## REMARKS

Respectfully submitted,  
Yasushi NAGATA et al.

Fig. 4A

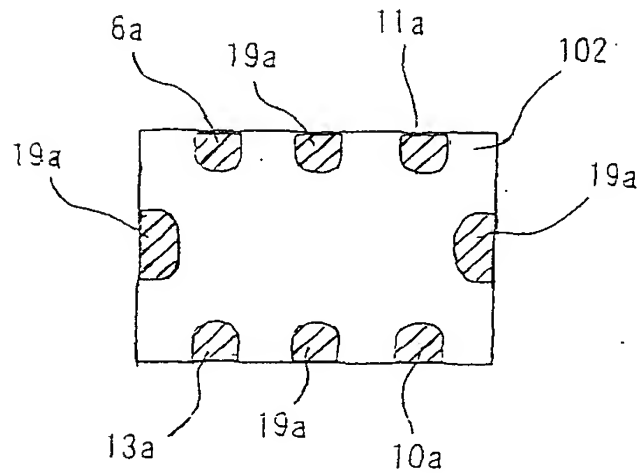
The Examiner objects to the drawings on the ground that the spacing feature specified in claim 6 is not shown in the drawings. Applicants respectfully traverse this objection, submitting that a careful examination of Fig. 4 (herein re-labeled as Fig. 4A) does in fact disclose the claimed space between the high-frequency terminals and the outer edge of the multi-layer assembly. However, in order to more clearly illustrate this feature, Applicants amend Fig. 4 to be labeled as Fig. 4A, and add an additional drawings, labeled as Fig. 4B, that presents an enlarged view of this portion of the multi-layer assembly. Further, Applicants amend the appropriate sections of the specification to change all reference to Fig. 4 therein to Fig. 4A, and to add appropriate text for the addition of Fig. 4A. No prohibited new matter has been added. In view of the current amendment, Applicants submit that the ground for this particular objection no longer

The Examiner additionally objects to the drawings as failing to disclose the land size feature specified in claim 14. Applicants respectfully traverse this drawing objection, submitting that the size relationship between the lands and the high frequency terminals is apparent in Figs. 1, Figs. 4 (re-labeled herein as Fig. 4A) and 5. Accordingly, Applicants submit that it is not necessary to amend the drawings with respect to this feature, and respectfully request withdrawal of this objection to the drawing.
